Downtown Mall Vehicular Crossings Illustrative Repair Concepts

December 2024

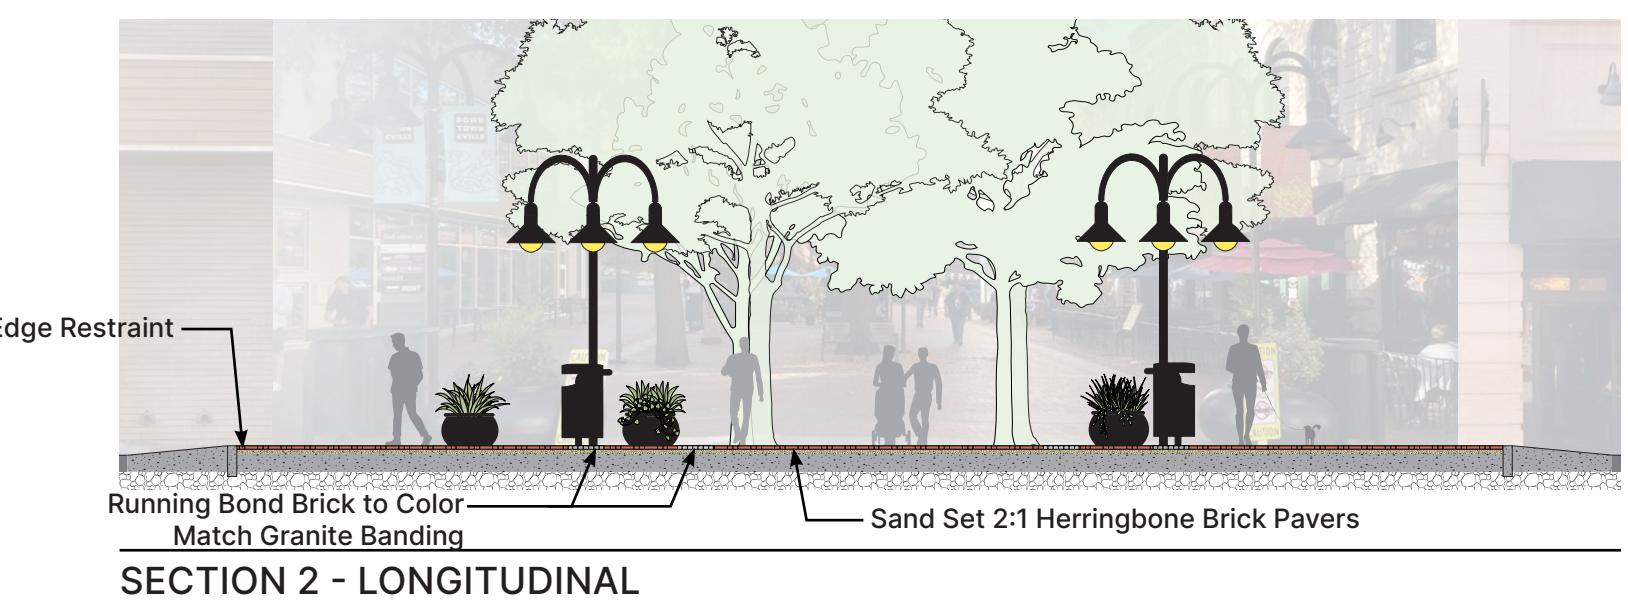
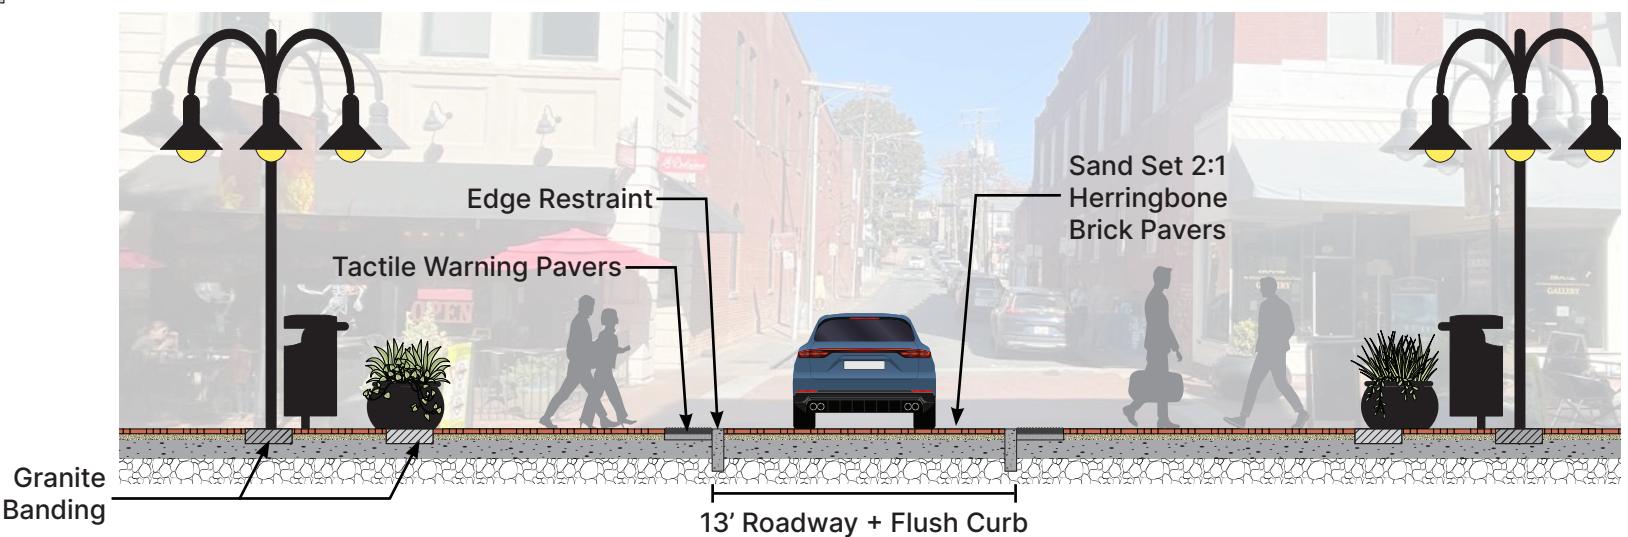
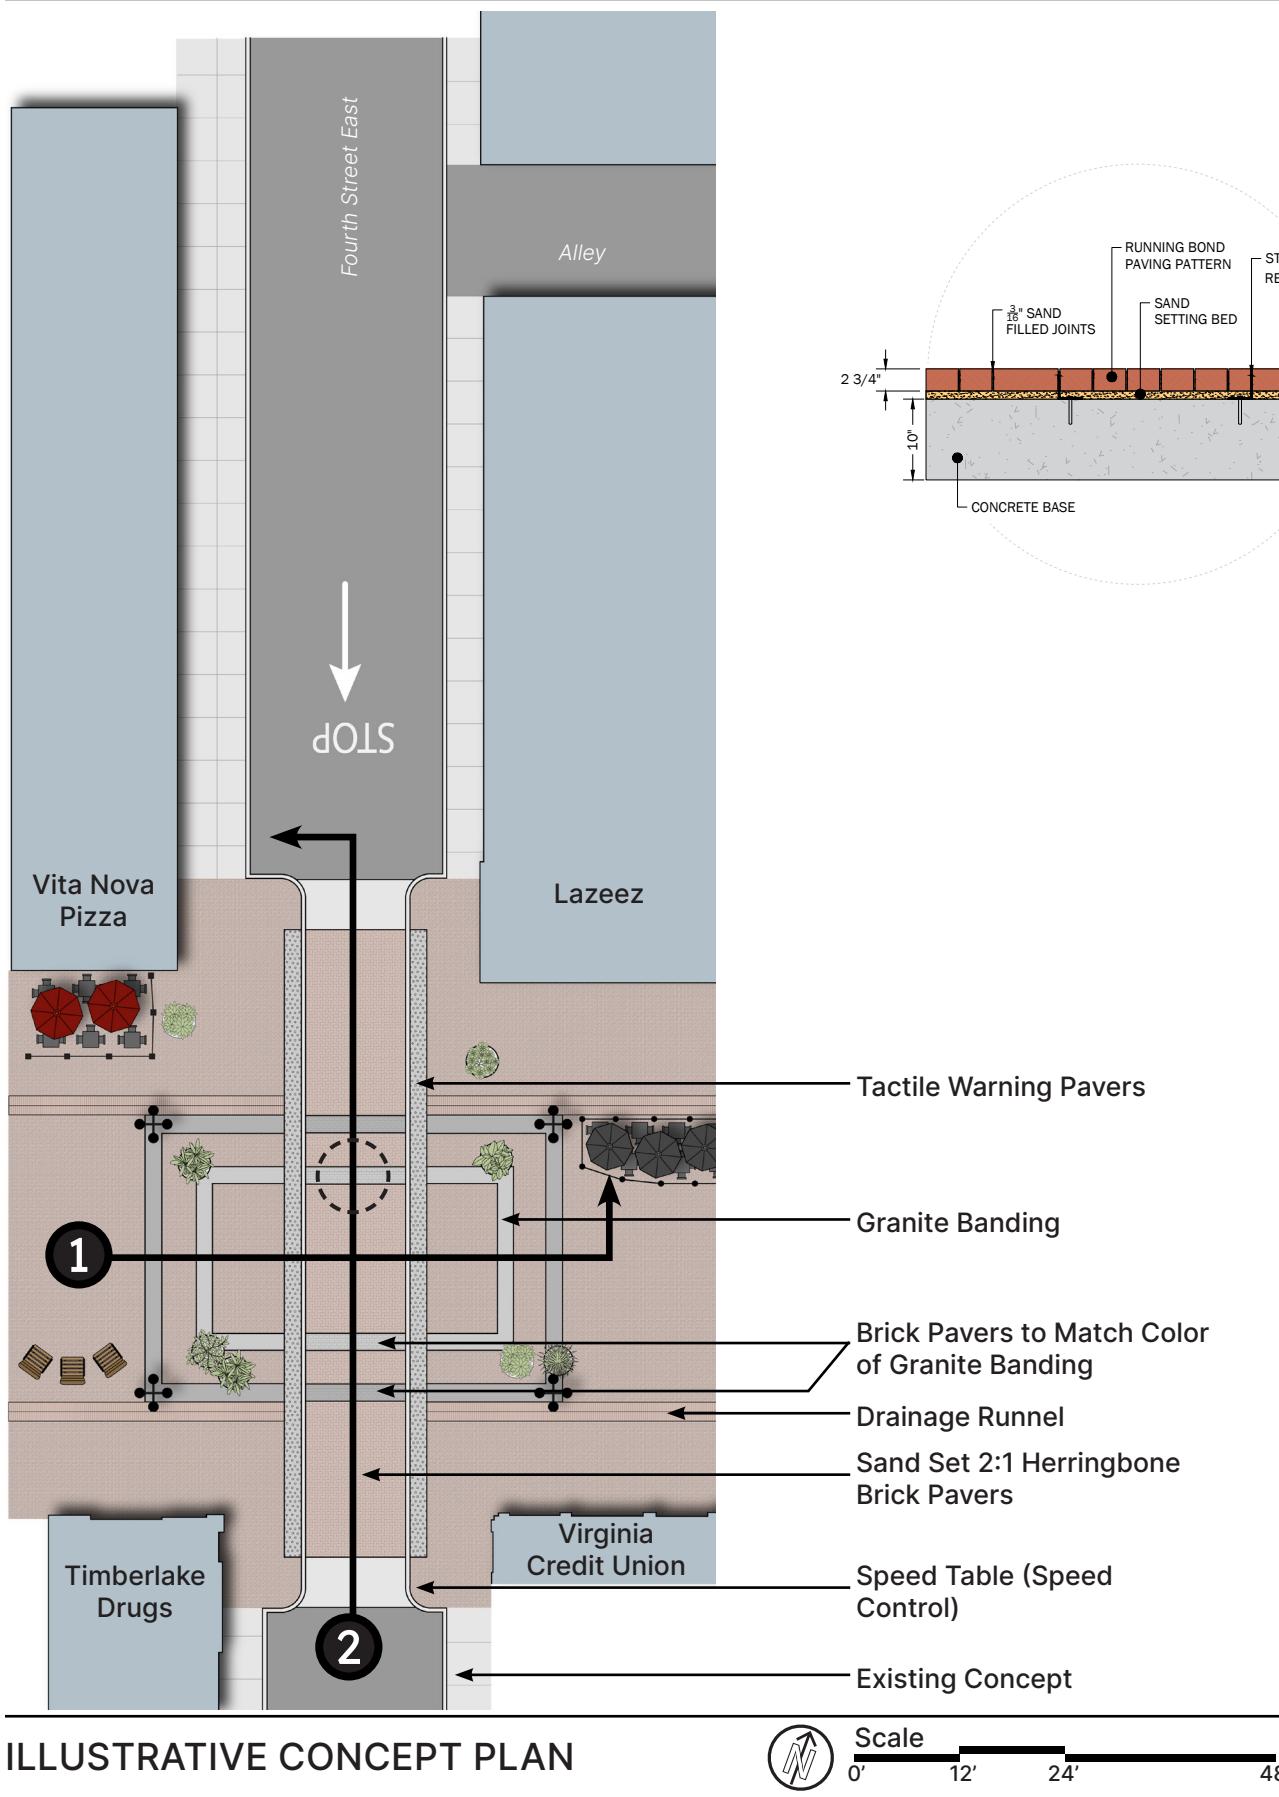
At the November 19 stakeholder meeting, initial concepts for a repaired vehicular crossing (pages 4 + 6) and a closed vehicular crossing (pages 5 + 7) were presented. The general consensus was that a modified version of the repaired vehicular crossing concept would be ideal, namely to maintain the visual cues of the granite banding. The concept below responds to the stakeholder feedback by balancing the design aesthetic with technical considerations. The granite banding pattern will be continued through the vehicular crossing with a color-matched brick laid in a running bond paving pattern. This running bond brick will require steel angle edge restraints to minimize movement from vehicular forces. The steel angle edge restraint will be placed on either side of color-matched brick, as shown in the detail to the left. Retractable bollards, not shown here, can be placed at either end of 2nd Street and 4th Street to allow the through streets to be temporary closed to vehicular traffic.

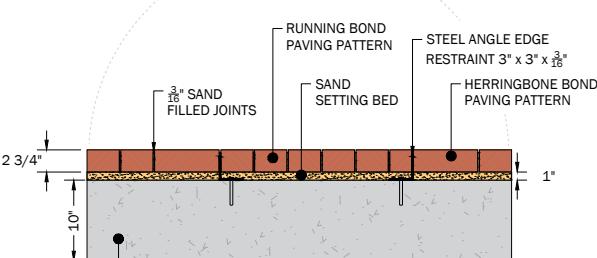
At the November 19 stakeholder meeting, initial concepts for a repaired vehicular crossing (pages 4 + 6) and a closed vehicular crossing (pages 5 + 7) were presented. The general consensus was that a modified version of the repaired vehicular crossing concept would be ideal, namely to maintain the visual cues of the granite banding. The concept below responds to the stakeholder feedback by balancing the design aesthetic with technical considerations. The granite banding pattern will be continued through the vehicular crossing with a color-matched brick laid in a running bond paving pattern. This running bond brick will require steel angle edge restraints to minimize movement from vehicular forces. The steel angle edge restraint will be placed on either side of color-matched brick, as shown in the detail to the left. Retractable bollards, not shown here, can be placed at either end of 2nd Street and 4th Street to allow the through streets to be temporary closed to vehicular traffic.
